Implementation modifications & design clarifications coming from iCAROS phase 1 REX

23 January 2025

Implementation changes – RD bidding properties – Minimum Activation Time

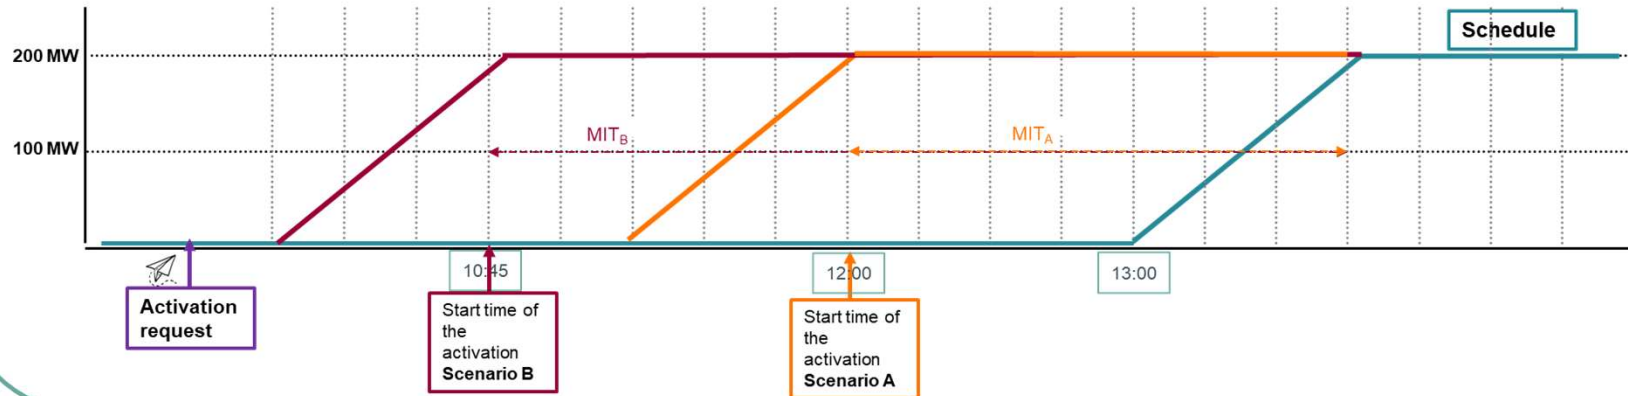
Issue with Minimum Activation Time (MIT) currently defined at the timeseries level
During start-up / shut-down, no easy way with the current properties to offer the full flexibility

- Unit schedule starts-up at 13:00
- For congestion issue, Elia needs to start-up the unit earlier:
 - Scenario A at 12:00 => Minimum Activation Time = 1h
 - Scenario B at 10:45 => Minimum Activation Time = 2h15

→ Definition of MIT properties at bid level with a 15min granularity (similar as Maximum Energy Level (MEL))

Implementation changes – RD bidding properties – Minimum Activation Time

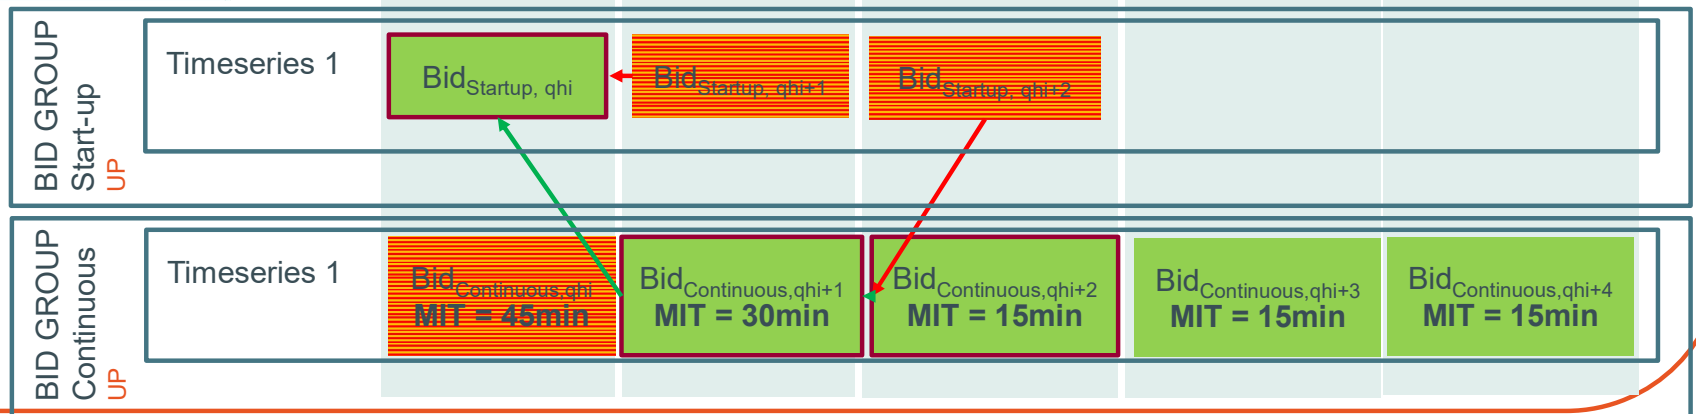
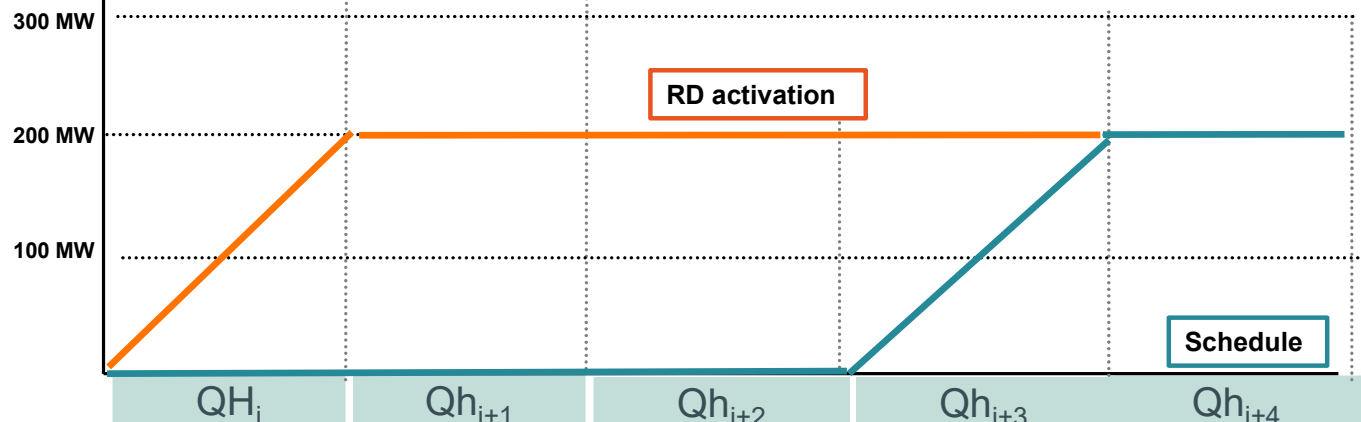
RD activation will take into consideration the MIT of the first activated bid in the timeseries
By default MIT = 15'

→ Definition of MIT properties at bid level with a 15min granularity - example

Implementation changes – RD bidding properties – Full Activation Time

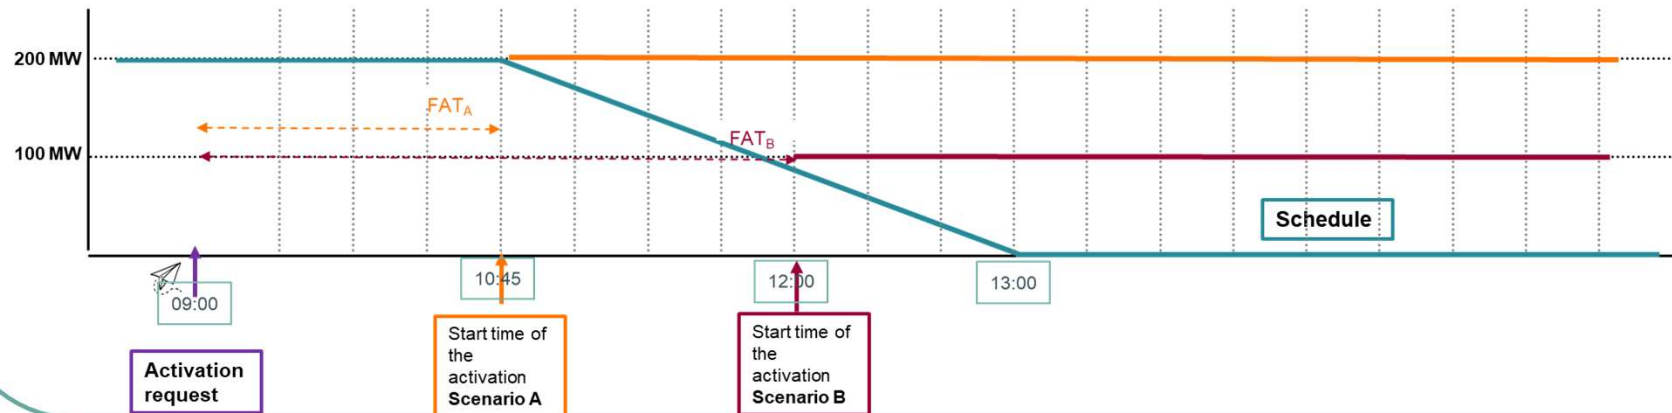
Issue with Full Activation Time (FAT) currently defined at the timeseries level

During start-up / shut-down, not possible/easy way with the current properties to offer the full flexibility

- Unit schedule starts a slow shut-down at 10:45
- At 9am, for congestion issue, Elia needs avoid the shut-down
 - Scenario A when the unit start the ramp-down to keep at Pmax
 - Scenario B when the unit has already started the ramp-down to keep the unit at Pmin

$FAT_A \neq FAT_B$

- Definition of FAT properties at bid level with a 15min granularity (similar as Maximum Energy Level (MEL))

Implementation changes – RD bidding properties - conditional links specific for start-ups/shut-downs (p27 of the Technical Guide (section 5.2 Complex RD submission))

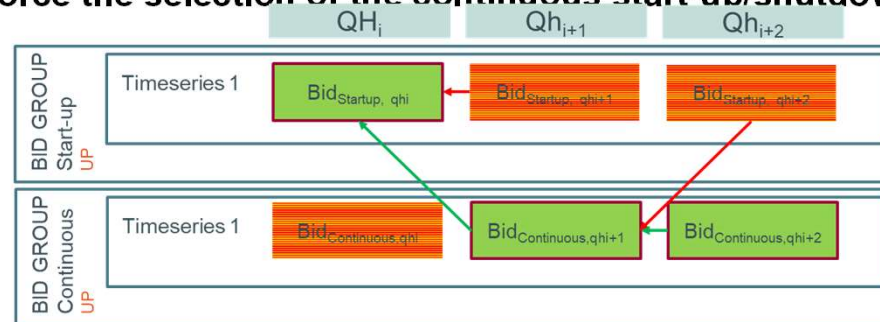
Issue with start-up / shut-down to force the selection of the continuous start-up/shutdown bids with MIT

2 Bid Groups to reflect start-ups:

- **Start-up bids**
 - initially **available**
 - Becomes **unavailable** if Bid_{Startup, qh-1} is activated: **A55 link**
 - Becomes **unavailable** if Bid_{Continuous, qh-1} is activated: **A55 link**
- **Continuous bid**
 - is initially **unavailable**
 - **Has a MIT**
 - Becomes available if Bid_{Startup, qh-1} is activated: **A67 link**
 - Or Becomes available if Bid_{Continuous, qh-1} is activated: **A67 link**

→ Creation of new conditional links specific for start-ups/shut-downs (ie A95 to use additionally for the start-up bid in order to guarantee that the continuous bid is always activated if the start-up bid is activated)

A95: bid (start-up) initially available,

- becomes unavailable if linked bid (Continuous) is not activated in qh+1
